# CIRCUIT A.W.A. TELEVISION RECEIVER CHASSIS - 50-00 SERIES

2nd Edition August, 1969

### 50 SERIES CIRCUIT IMPROVEMENT

# CIRCUIT A.W.A. TELEVISION RECEIVER CHASSIS — 50-00 SERIES

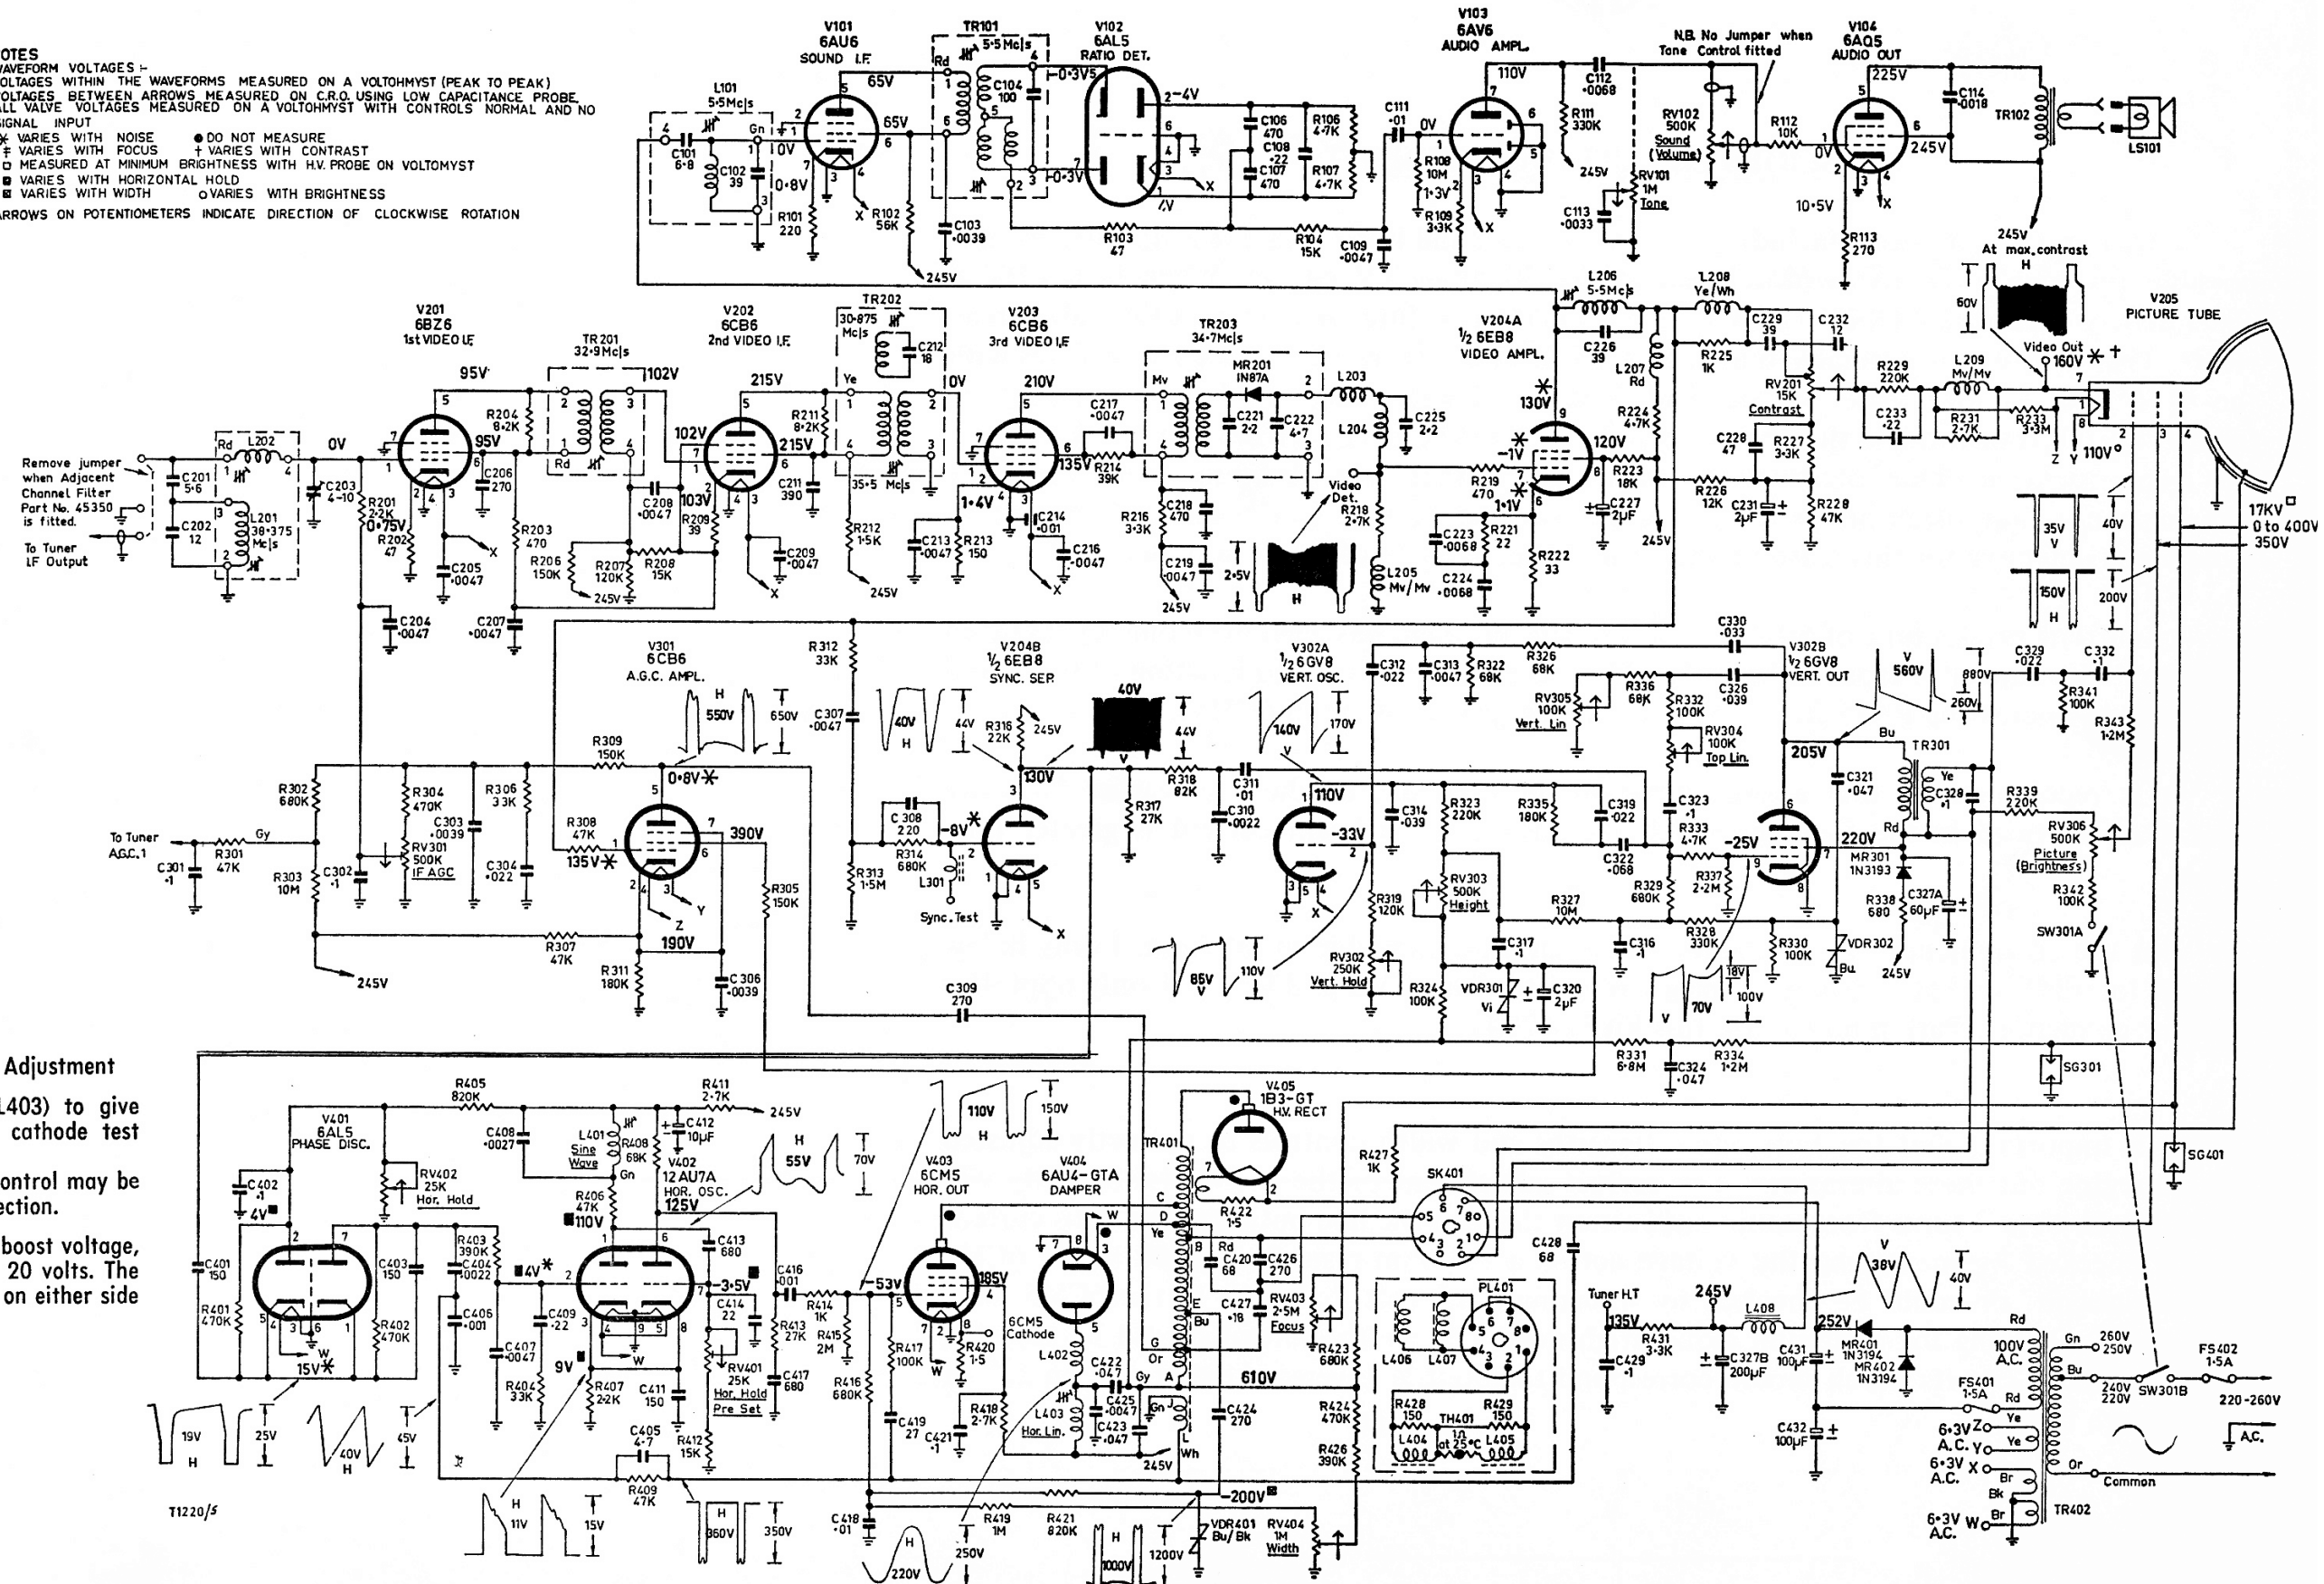
Under some conditions including incorrect width and horizontal linearity settings, it is possible for high EHT to be developed in the 50 series TV chassis. When high EHT is generated, greater than 18KV (zero beam) premature failure of EHT rectifier valves may result. This failure will normally burn up R427 1k ohm ½w resistor, which is in series with the EHT lead. In some cases in the field, because of wax being noted as having dropped from the EHT transformer, the transformer, as well as the EHT rectifier and the 1k resistor, has been replaced. Our observations have shown that wax dripping from the EHT transformer, is not often an indication of transformer failure. Our tests on transformers replaced as defective for this reason indicate that the majority are in no way defective.

In current production of 50 series chassis, this problem has been overcome by addition of a 68pf 4Kv capacitor from cathode of 6AU4—GTA valve (pin 3) to junction of C426 and C427 and by increasing R415 from 1meg to 2.2meg (grid resistor on 6CM5).

It is recommended that above alterations be carried out whenever earlier 50 series chassis are serviced in the field, in which the EHT at zero beam current is greater than 18KV.

For the convenience of our clients, these parts are available in kit form, 1 only 1k ½w resistor for EHT socket — 1 only 2.2meg ½w resistor for 6CM5 grid leak — 1 only 68pf 4Kv ceramic condenser. Part number for this kit is 47047

It is important that the horizontal linearity and width controls be correctly adjusted after carrying out these alterations. The correct adjustment of the horizontal linearity will be not more than 2 turns from minimum current through the line output valve. This current can be checked by measuring the voltage across a 1.5 ohm resistor inserted in the 6CM5 cathode circuit, or could be checked by inserting a 12 volt dial light in the 6CM5 plate circuit and adjusting for minimum globe brightness. The width control should be adjusted for 610 volts  $\pm$  20 volts which should correspond to about ¾" overscan either side on 23" or 25" picture tube.
